Amendment Sheet

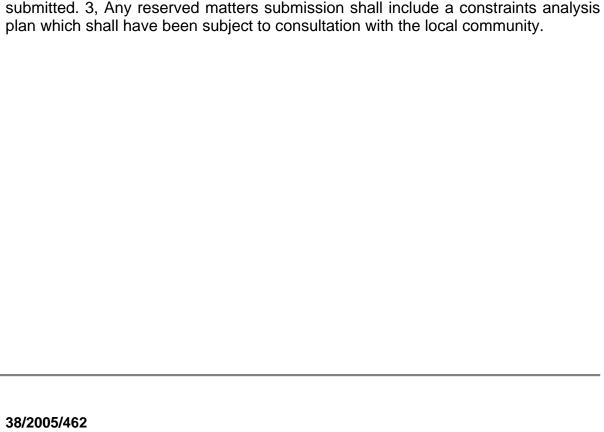
ONE ADDITIONAL LETTER from the Residents Action group raising the following points; 1. I note that on Drawing number 2706-20-230 the IT building is stated as now being 'single storey'. I trust that this is not an error on the Hospital's part , you will recall that their original application did not even refer to the IT building. We do not object to a single building. However, we would make it clear that we would object most vehemently if the single storey building has any windows above the existing fence level of the adjoining boundary of 50 Ashley Road. 2. I cannot see that the revised Drawings make any reference to shadows that will be cast over the adjoining properties in Ashley Road. This was specifically requested at the Resident Action Group's meeting with the Hospital's Director of Planning and Strategic Project Managers on 17 November. The whole issue of shadows cast by the proposed new buildings appears to have been ignored by the Hospital - and one

has to wonder why. 3. Although the revised Drawings 2706-20-231-233 show a BRE line, I understand that this is taken from too high a point. 4. The fact that Drawing 2706-20-234 shows a large tree in the back garden of No.50 Ashley Road when in fact there is no such tree must be viewed as deliberately misleading. It also makes us question exactly how much of the detail in the revised drawings can be relied on.
